REVISION TRANSMITTAL

This sheet transmits Revision 1 to SB525-34-107, which:

NAVIGATION - GARMIN HARDWARE AND SOFTWARE UPDATE TO VERSION 4.8.9

SB525-34-107
Page 1 of 31

Figure 1. Wiring Modification (Sheet 1)

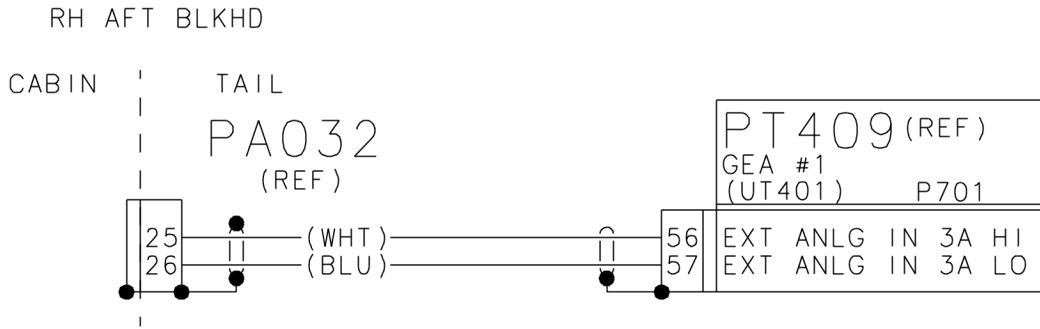
- B. (Airplanes equipped with the Stormscope option) (Refer to Figure 1, Sheet 1.) Modify the wiring.
 - (1) Open the left nose baggage compartment door.

- (5) Remove the PN836 electrical connector from the Stormscope processor.
 - (6) Remove the PN409 electrical connector from the left avionics pallet.
 - (7) Install the 26PN836-77PN409 Electrical Wire with two M39029/58-362 Connector Pins.

- (8) Install the 77J3-70P606 Electrical Wire using two M39029/58-362 Connector Pins.
 - (9) Install the PN836 Electrical Connector in the Stormscope processor.

Figure 1. Wiring Modification (Sheet 2)

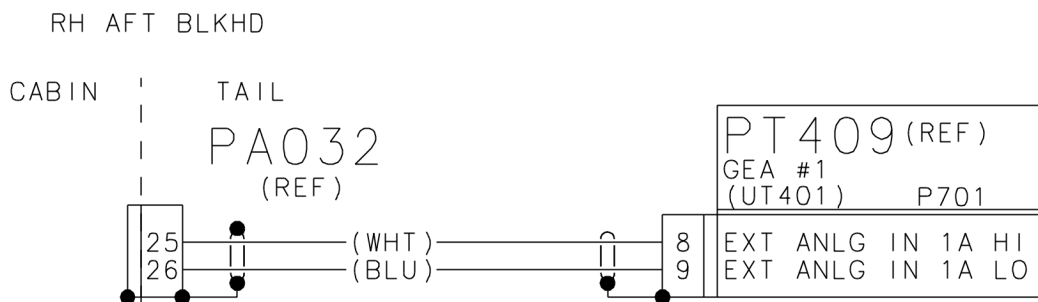
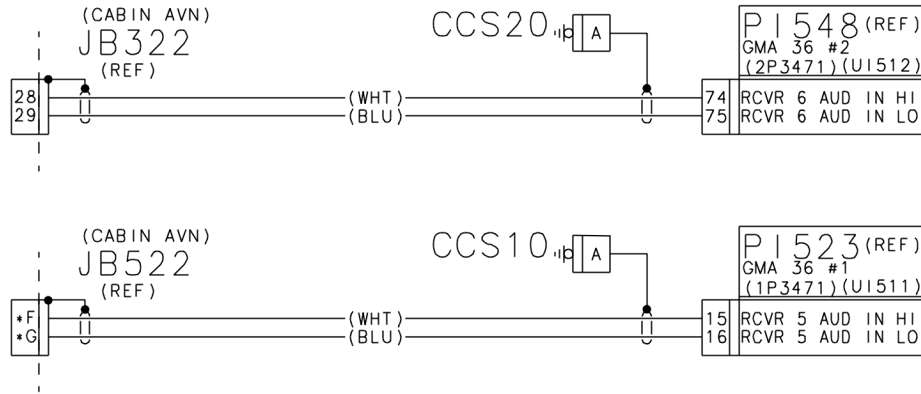
- B. (Refer to Figure 1, Sheet 2.) Do the Oxygen Pressure wiring modification. (Refer to the Citation Standard Practices Manual, Chapter 20, Splices, Terminals and Heat Shrinkable Tubing - Maintenance Practices.)

- (1) Remove the electrical wires from pins 56PT409 and 57PT409 and repin in 8PT409 and 9PT409.
 - C. (Airplanes equipped with the Windshear option that have incorporated SB525-34-97) (Refer to Figure 1, Sheet 7) Modify the wiring.

Figure 1. Wiring Modification (Sheet 3)

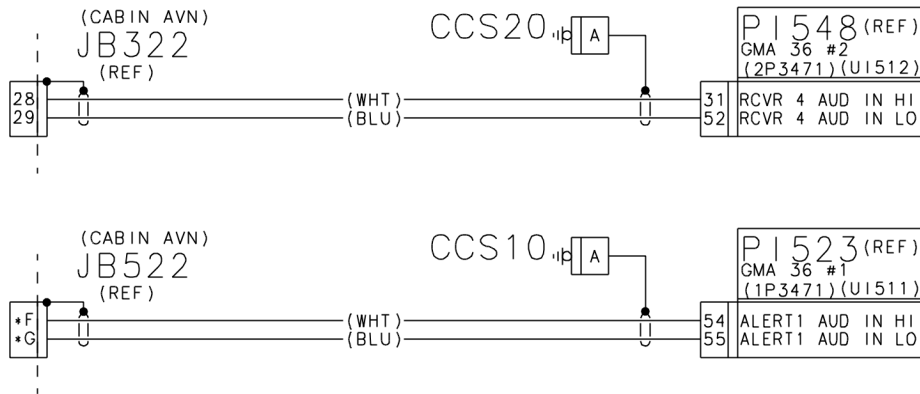
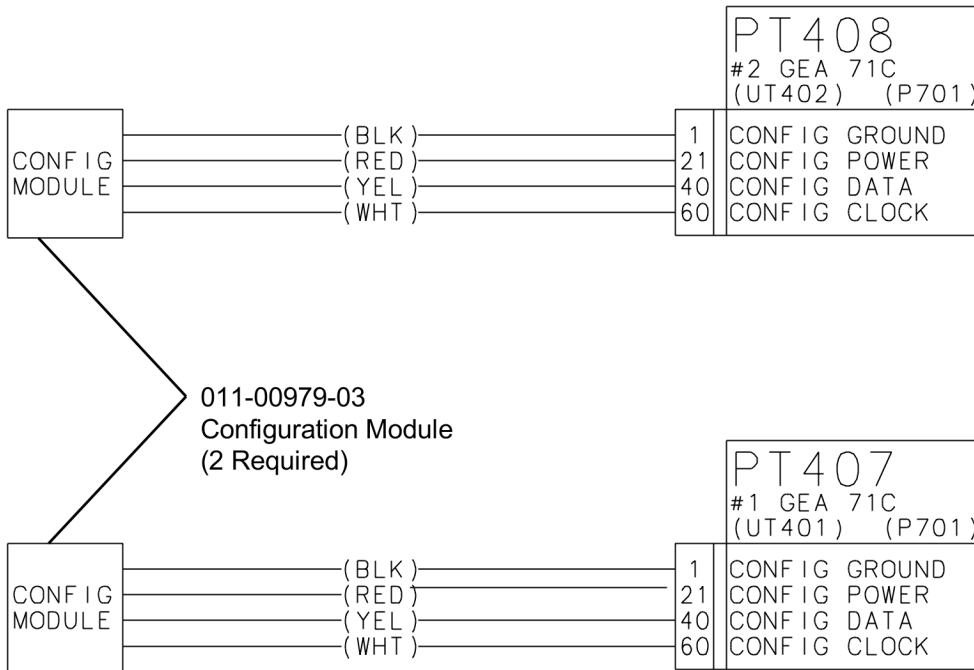
- B. (Refer to Figure 1, Sheet 3.) Do the DME Option Wiring Modification. (Refer to the Citation Standard Practices Manual, Chapter 20, Splices, Terminals and Heat Shrinkable Tubing - Maintenance Practices.)

- (1) Remove the electrical wire from pins 74PI548 and 75PI548 and install in pins 31PI548 and 52PI548.
 - (2) Remove the electrical wire from pins 15PI523 and 16PI523 and install in pins 54PI523 and 55PI523.

Figure 1. Wiring Modification (Sheet 4)

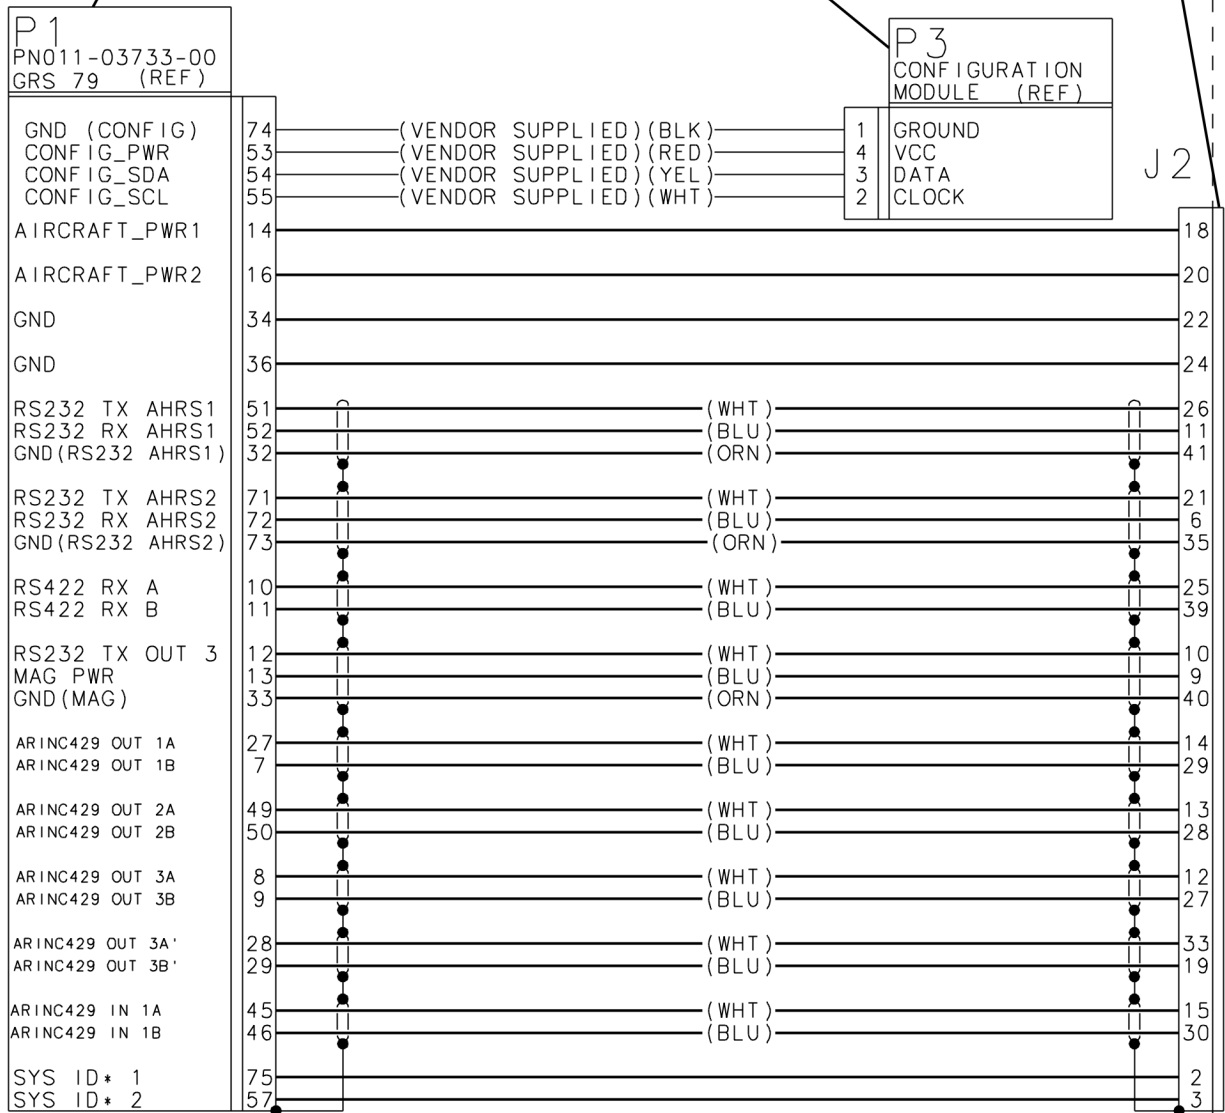
- (5) Install the PT407 Electrical Connector in the engine airframe interface unit.
 - D. (Refer to Figure 1, Sheet 4.) Install the 011-00979-03 Configuration Modules in the PT407 and PT408 Connector. (Refer to the Citation Standard Practices Manual, Chapter 20, Splices, Terminals and Heat Shrinkable Tubing - Maintenance Practices.)

- (1) Install the 011-00979-03 Configuration Module in the PT407 Connector.
 - (2) Install the 011-00979-03 Configuration Module in the PT408 Connector.

Figure 1. Wiring Modification (Sheet 6)

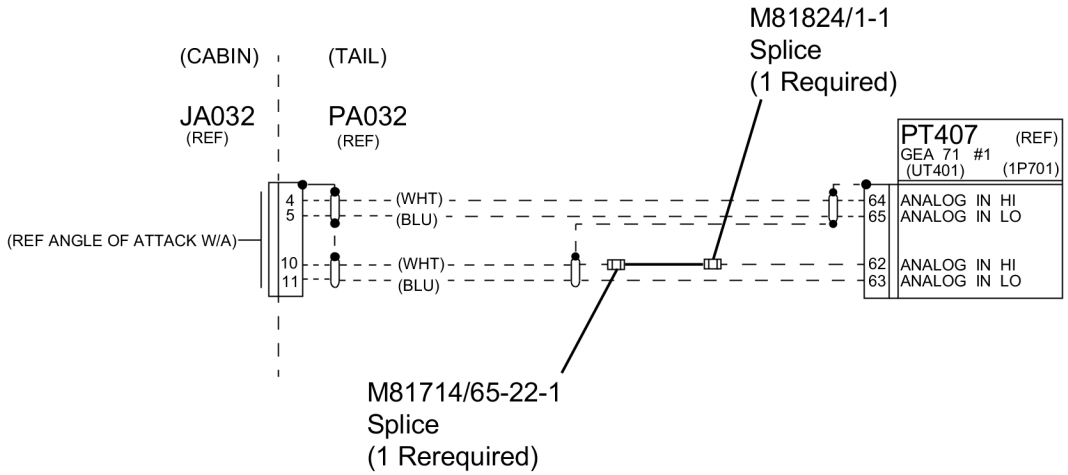
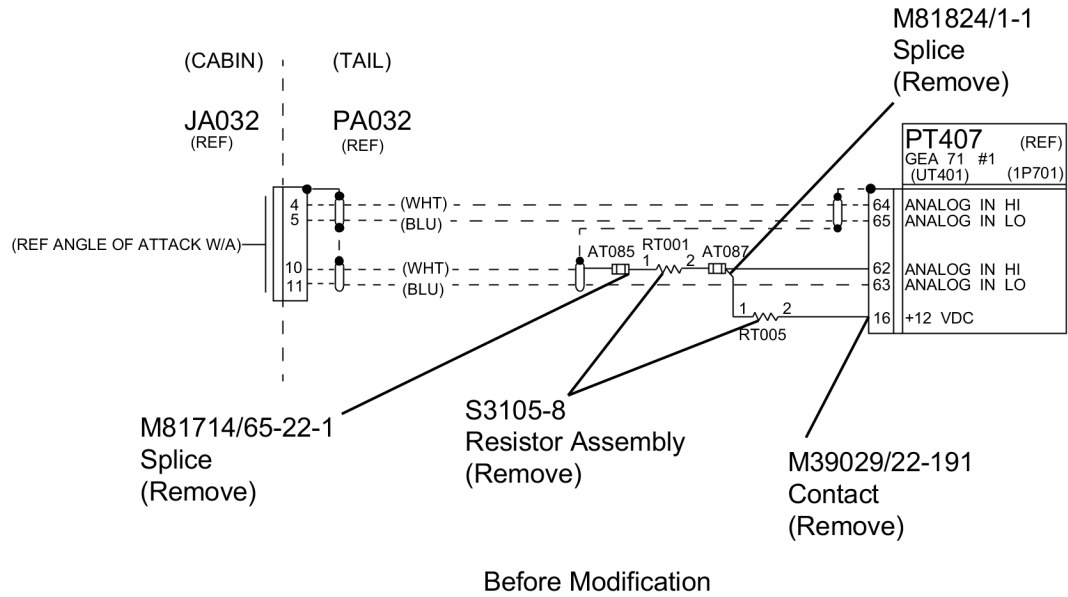
- (12) Engage the NAV IAU 1 circuit breaker located on the right circuit breaker panel in the cockpit.
 - C. (Refer to Figure 1, Sheet 6.) Do the GIA 64E Wiring Modification. (Refer to the Citation Standard Practices Manual, Chapter 20, Splices, Terminals and Heat Shrinkable Tubing - Maintenance Practices.)

- (1) Install the 1P603-69J4 (ORN), 21P603-70J4 (WHT/ORN), 40P603-71J4 (BLU), 60P603-72J4 (WHT/BLU)] Ethernet Cable with four M39029/56-351 Contacts and four M39029/58-363 Contact Pins and two S2974-8 Shield Terminations.

- (2) Install the 21P603-70J4 (WHT/ORN), 1P603-69J4 (ORN), 60P603-72J4 (WHT/BLU), 40P603-71J4 (BLU) Ethernet Cable with four M39029/56-351 Contacts and four M39029/58-363 Contact Pins and two S2974-8 Shield Terminations.

- (3) Install the 69PN411-71PN412 (ORN), 70PN411-72PN412 (WHT/ ORN), 71PN411-69PN412 (BLU), 72PN411-70PN412 (WHT/BLU) Ethernet Cable with four M39029/56-351 Contacts and four M39029/58-363 Contact Pins and two S2974-8 Shield Terminations.

Figure 1. Wiring Modification (Sheet 7)

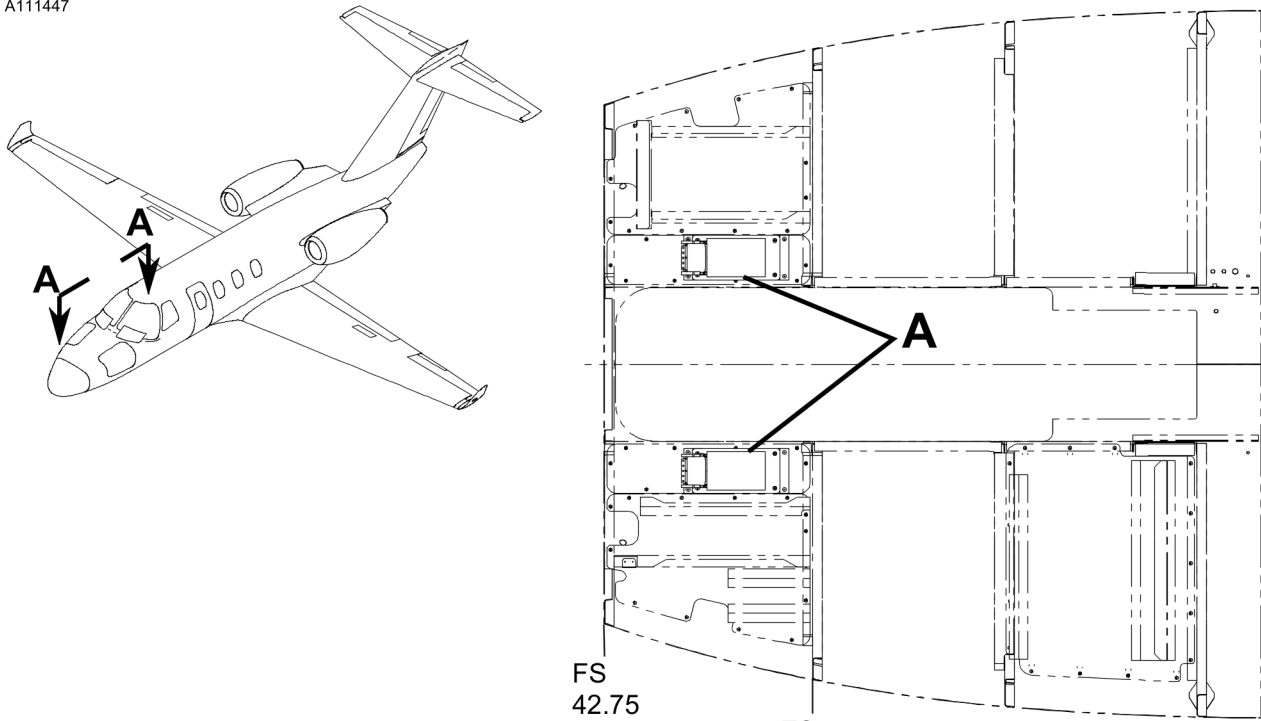
- (3) Remove the two S3105-8 Resistors, one M81714/65-22-1 and one M81824/1-1 Splice
 - (4) Install M81044/12-22-9 Electrical Wire cut to fit to replace the S3105-8 Resistor with one M81714/65-22-1 and one M81824/1-1 Splice. (Refer to the Citation Standard Practices Manual, Chapter 20, Wiring and Resistors - Maintenance Practices.)

Figure 2. AHRS Remote Rack Installation (Sheet 1)

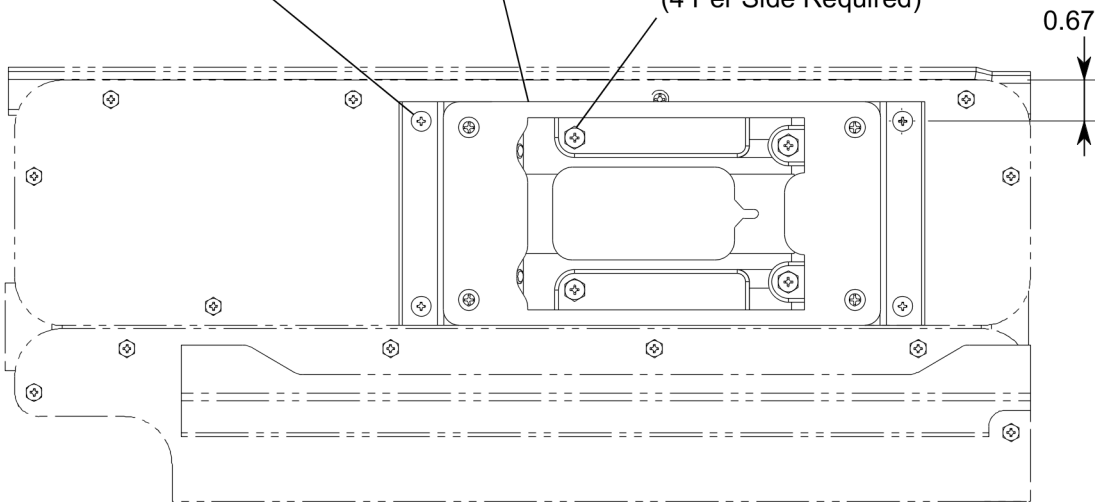
- C. (Refer to Figure 2, Detail A and View A-A.) Install two new 117-00608-00 GRS 79 Remote Racks.
 - (1) Remove and keep the MS27039-0808 Screws from the two 115-00459-00 GRS 77 Mounting Racks.

- (2) Remove and discard the two 115-00459-00 GRS 77 Mounting Racks.
 - (3) Install two 6397107-2 Channel Assemblies for each 117-00608-00 GRS 79 Remote Rack installation with the kept MS27039-0808 Screws.
